SITE INSTRUCTION

PROJECT: HAMPTON MANOR
25 BAKER HILL BLVD
STOUFFVILLE, ONTARIO

SITE INSTRUCTION: E-7

1.0 Reference Drawings E-1 (Site Plan) Issued

ELECTRICAL SITE PLAN			
PROPOSED RESIDENTIAL DEVELOPMENT 25 BAKER HILL BLVD.			
ROYAL PINE HOMES STOUFFVILLE, ONTARIO			
DRAWN	CM	CHECKED	MG
DATE	SEPT. 2015	PROJECT	14-016
		SCALE	1:200
		DRAWING	E-1
		OF	12

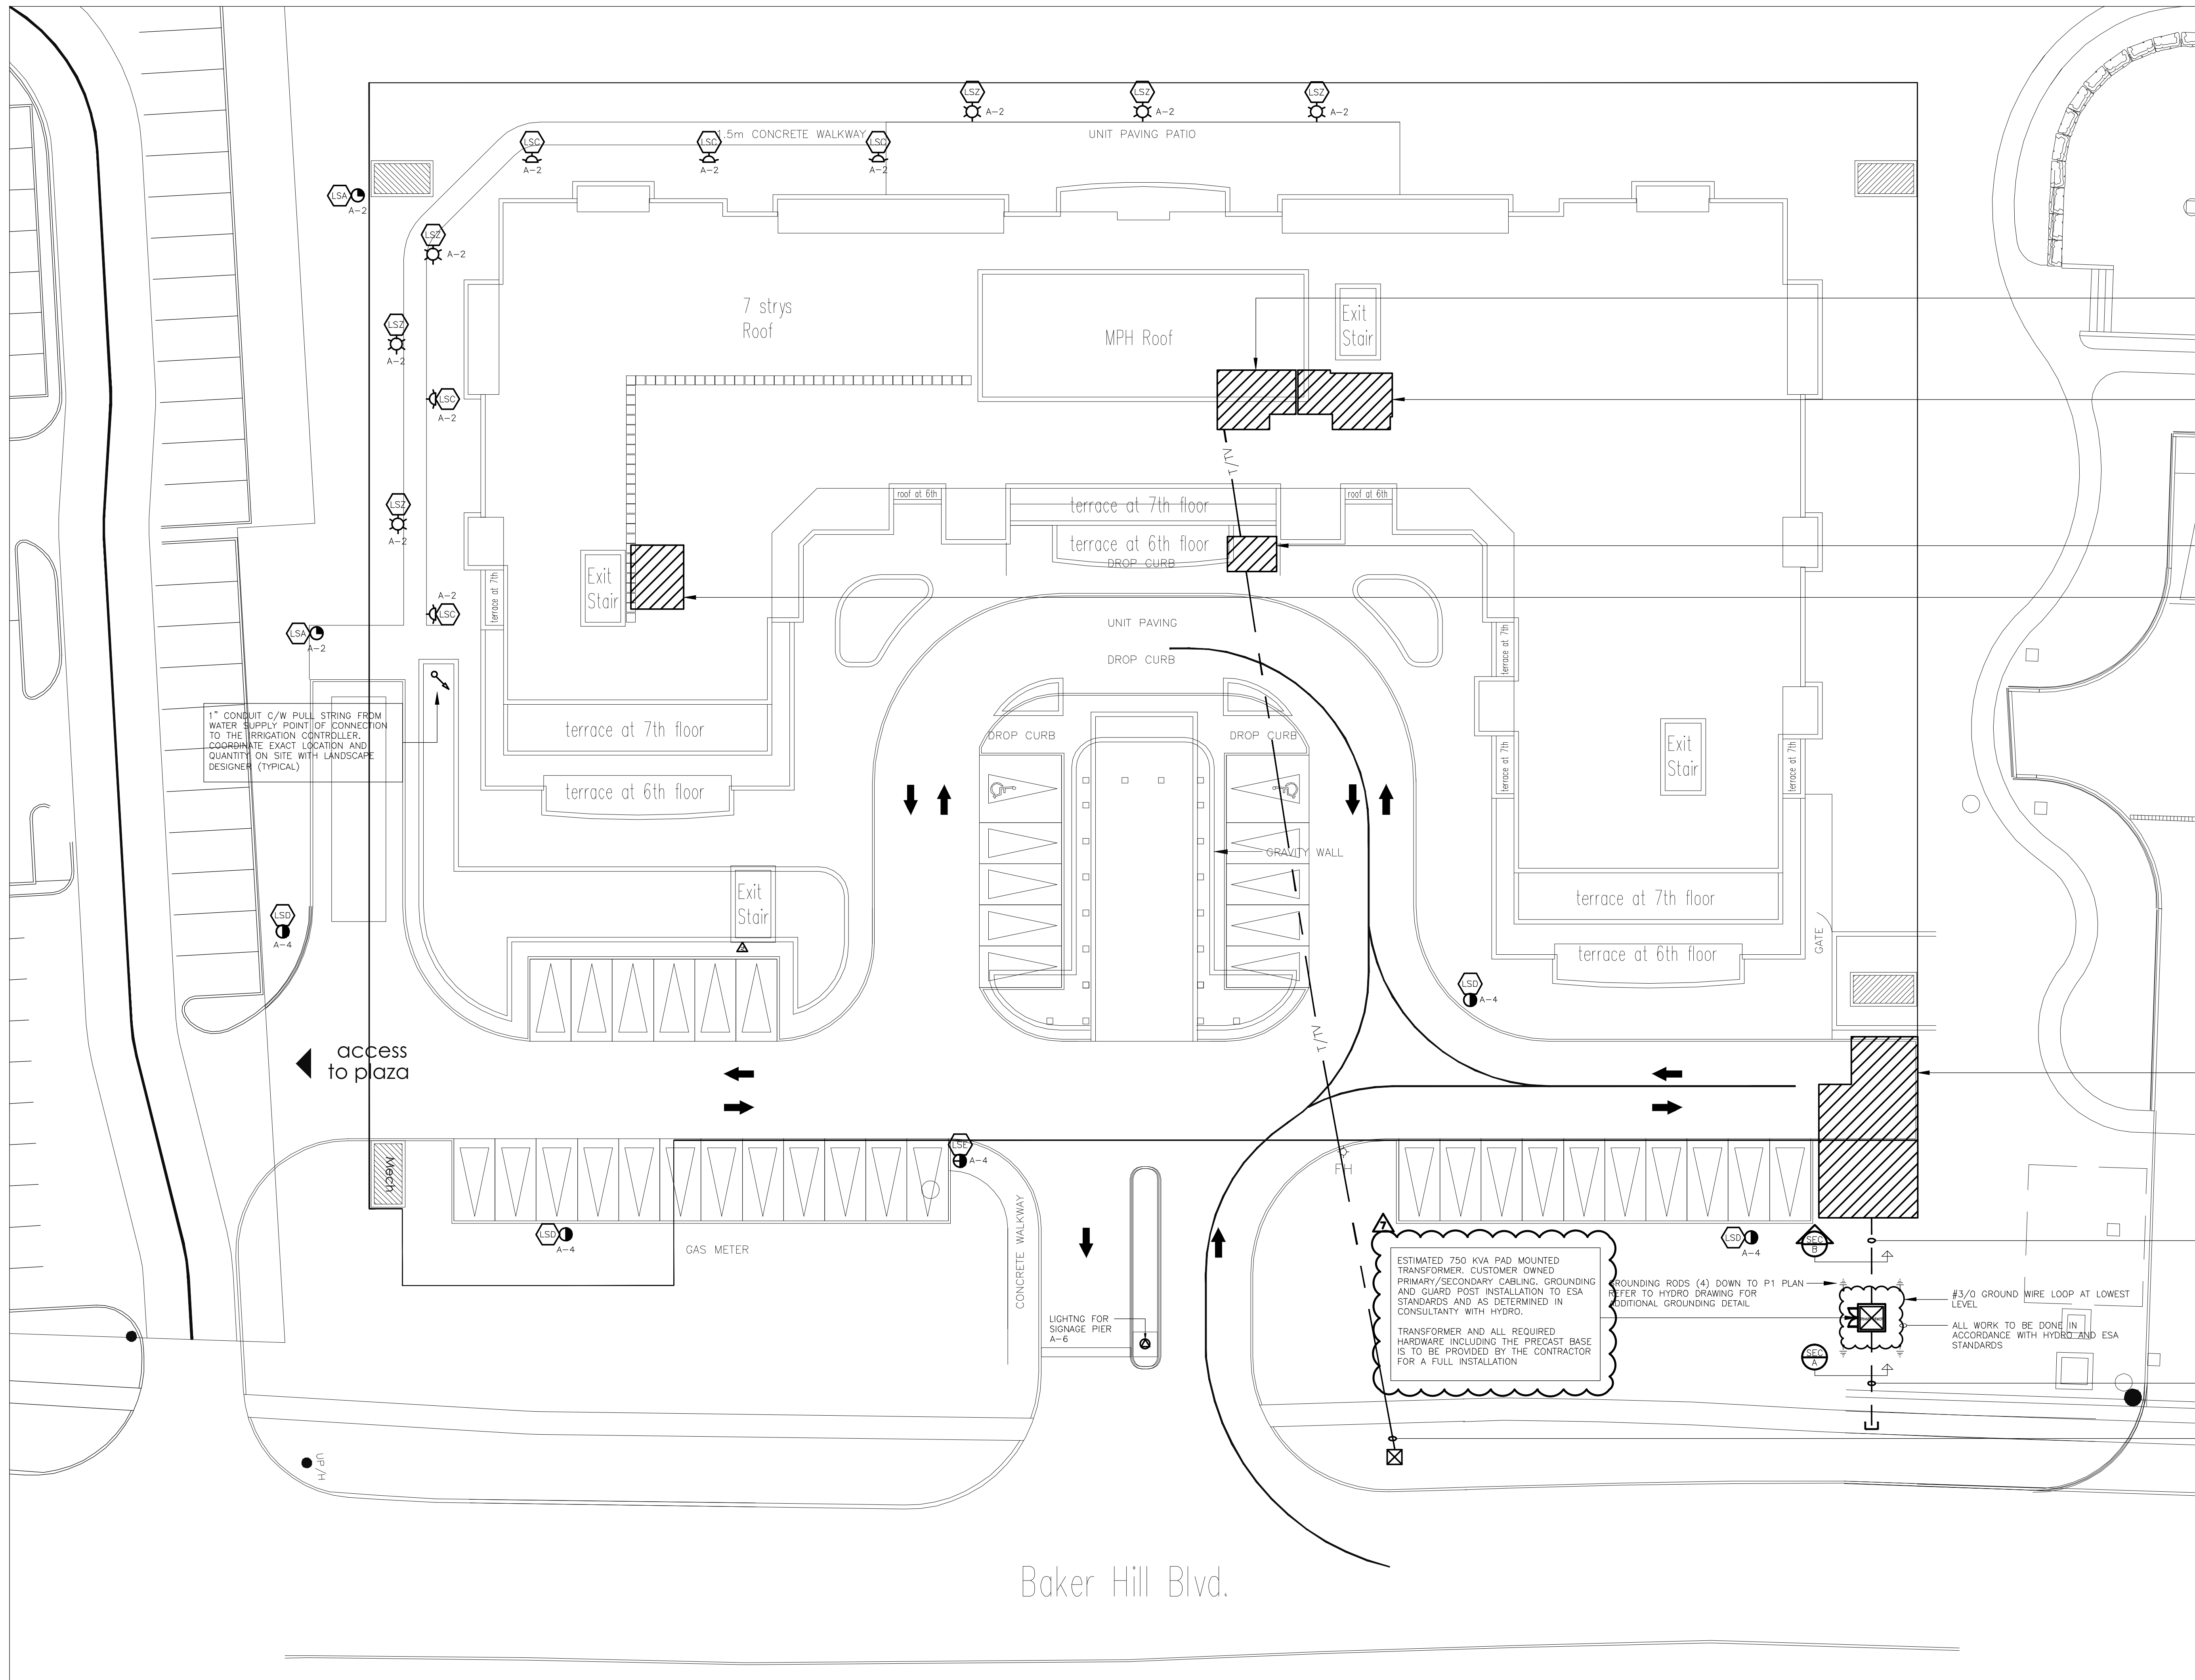
1.1 Revised: Transformer's note, as noted on drawing.
